# A47 Blofield to North Burlingham Dualling

## **Volume 6 6.8 Masterplan**

Deadline 5

## SCHEDULE OF CHANGES

DRAWING TITLE  
**MASTERPLAN SHEET 1 OF 7 TR010040/APP/6.8**

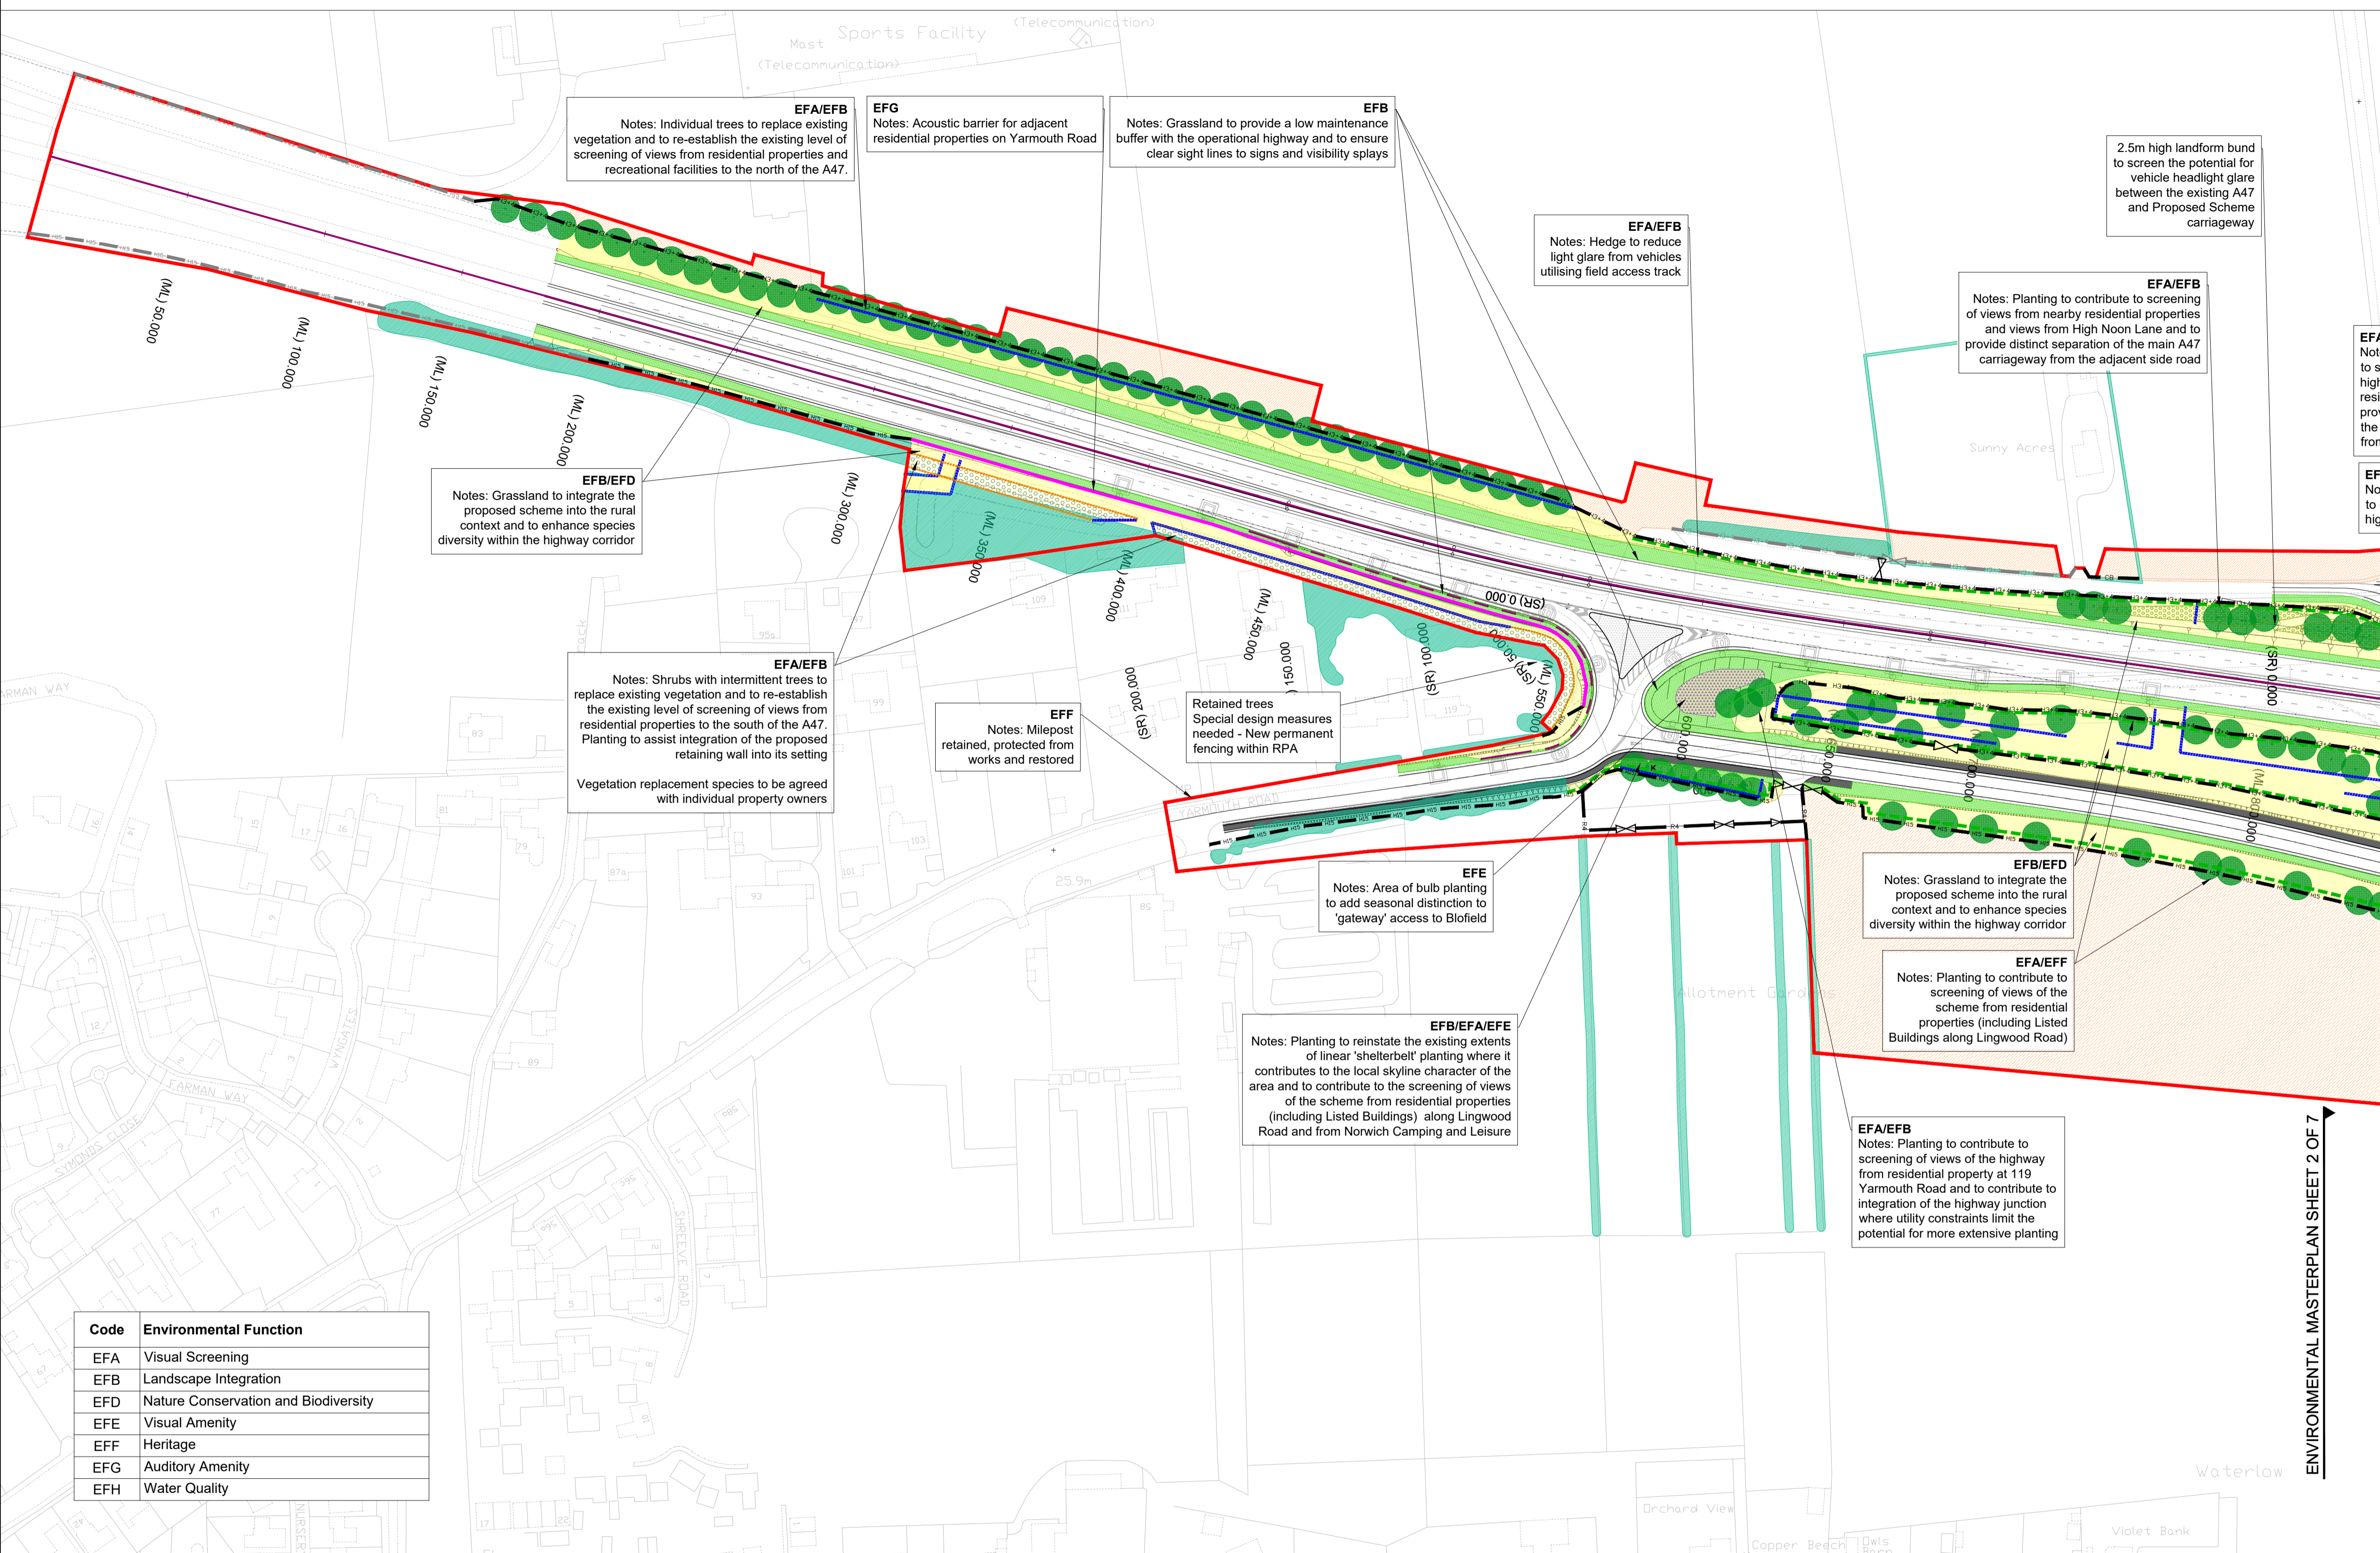
- Fenceline at Blofield Allotments updated to reflect preference of the Allotment Association (Sheet 1).
- Fenceline adjacent to the Agricultural Access Track relocated to reflect the agreement made with Norfolk County Farms.
- Landscaping updated to reflect additional loss of woodland and proposed replacement planting due to the change associated with Cadent Block Valve.
- Plant Schedule mixes updated.

**MASTERPLAN SHEET 4 OF 7 TR010040/APP/6.8**

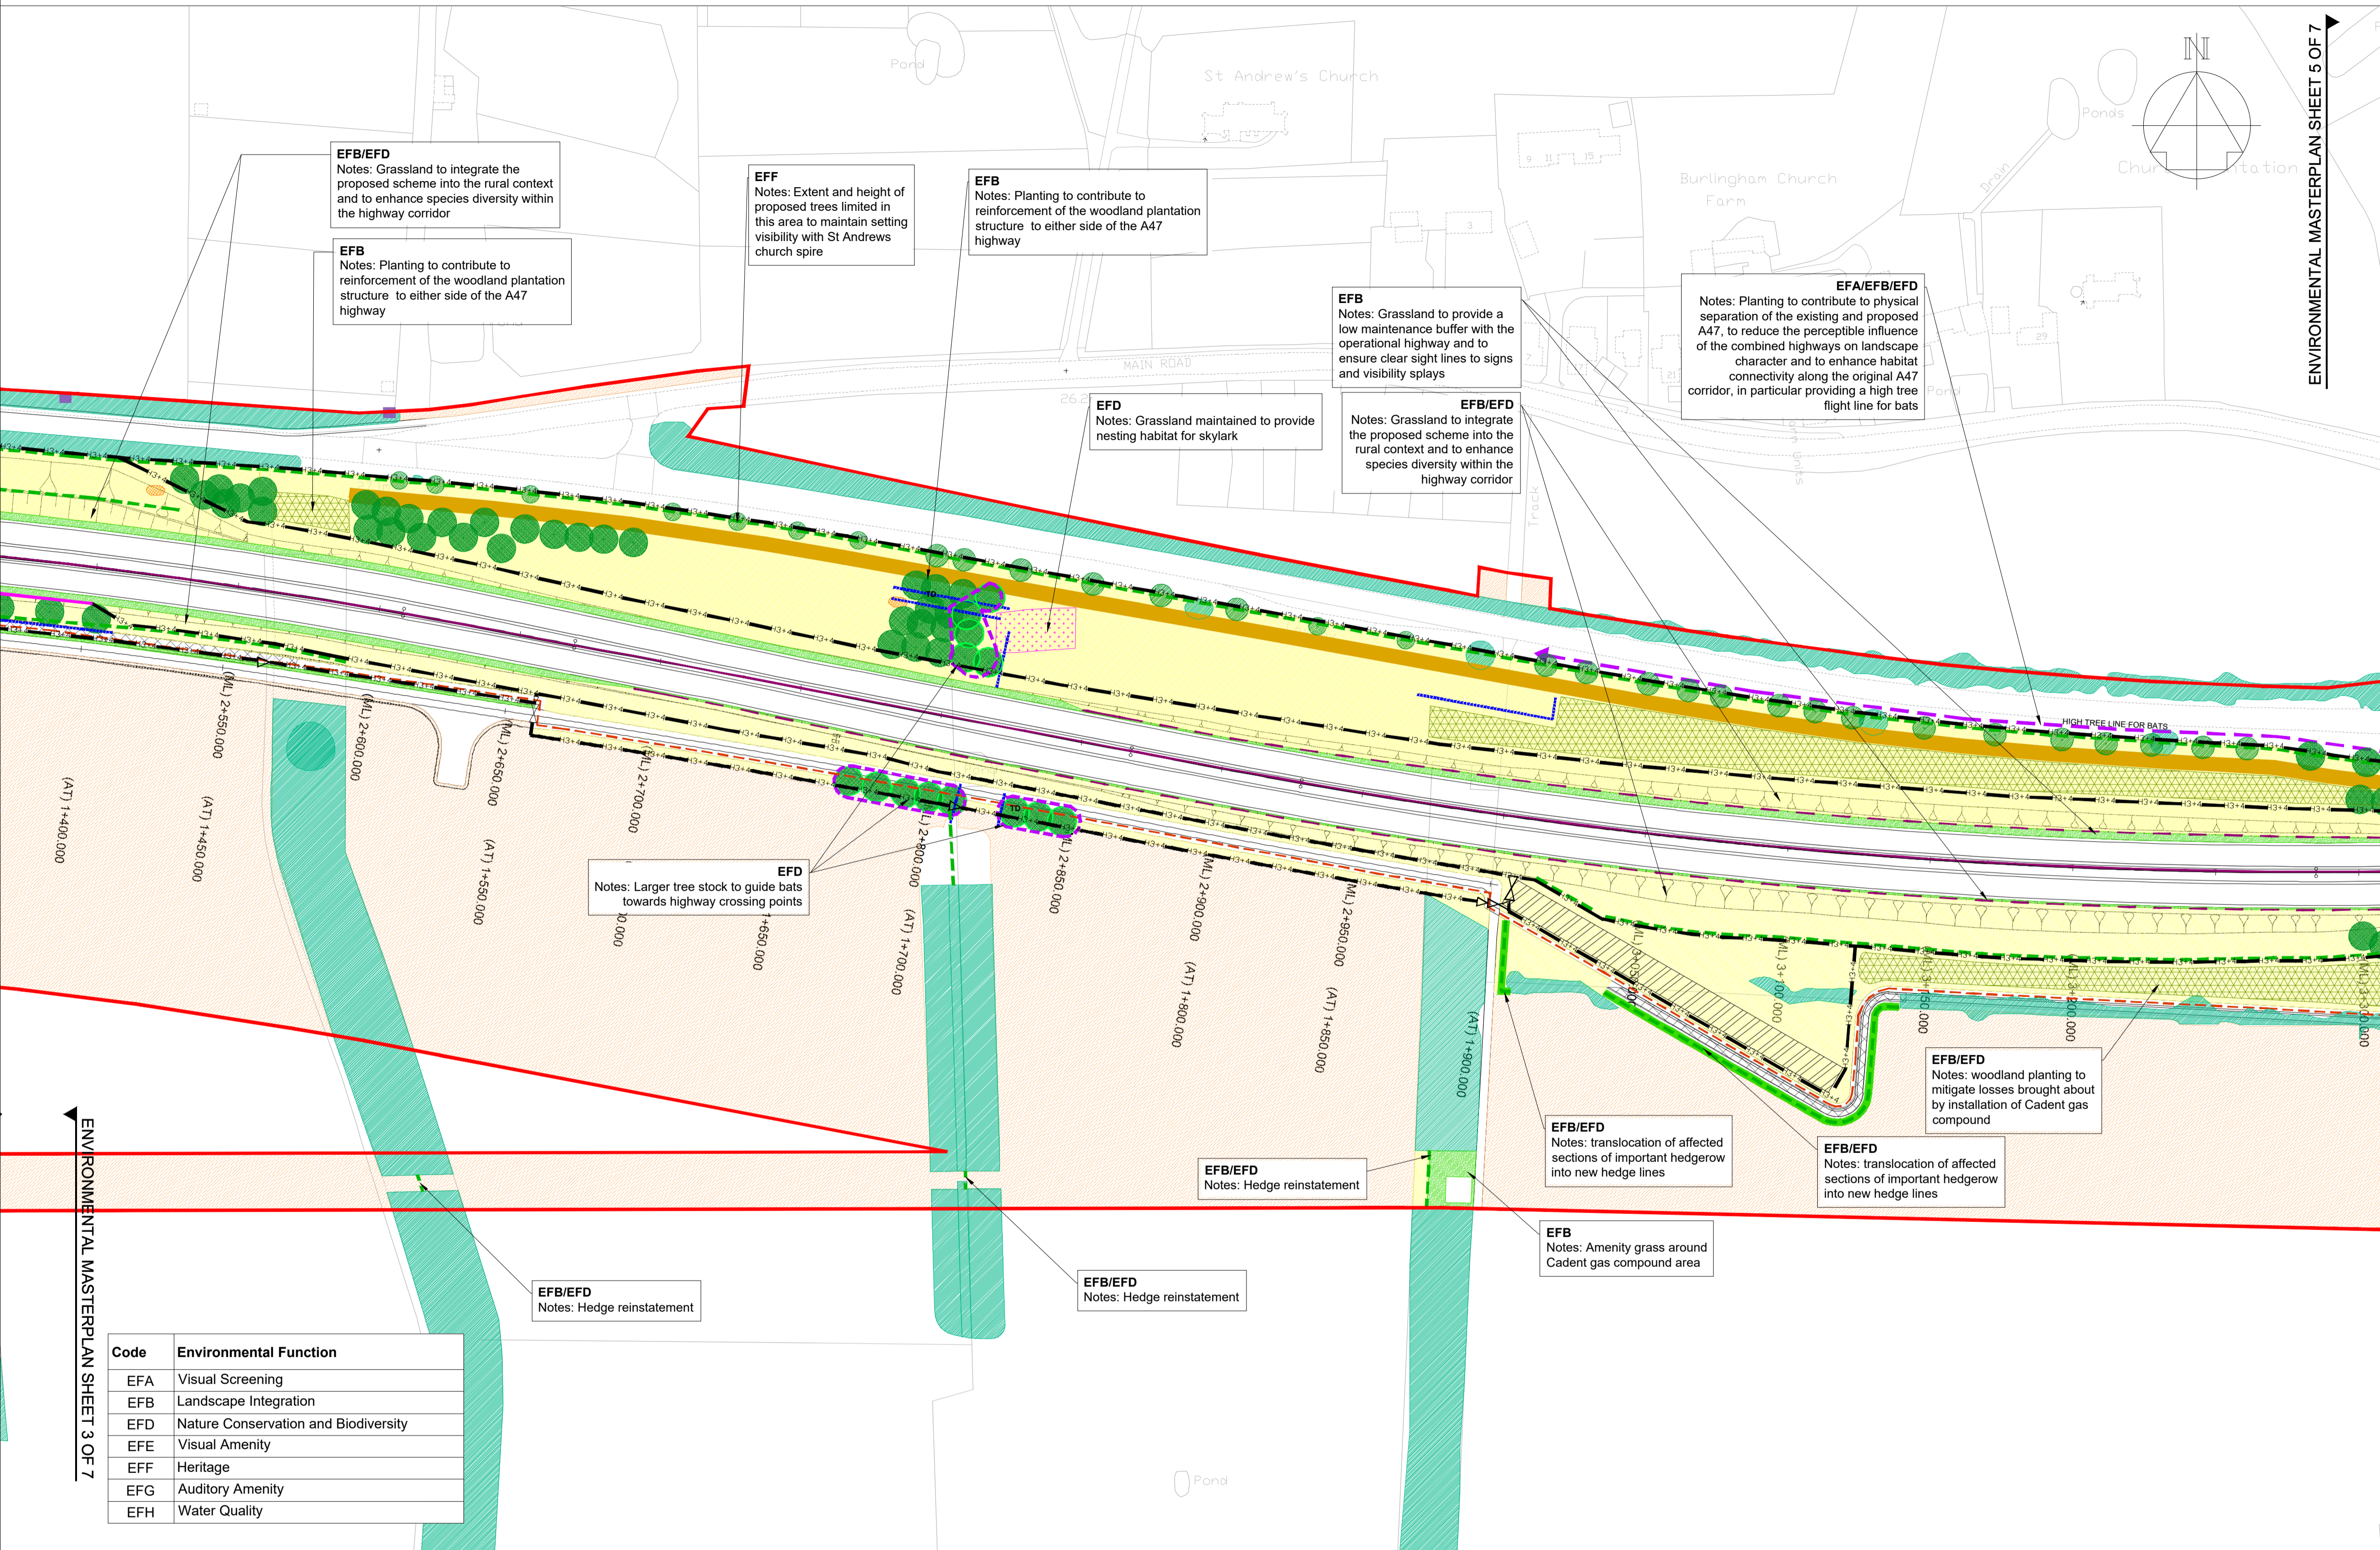
- Correction to sheet 4 to remove the proposed loss of woodland adjacent to the proposed Cadent Block Valve.
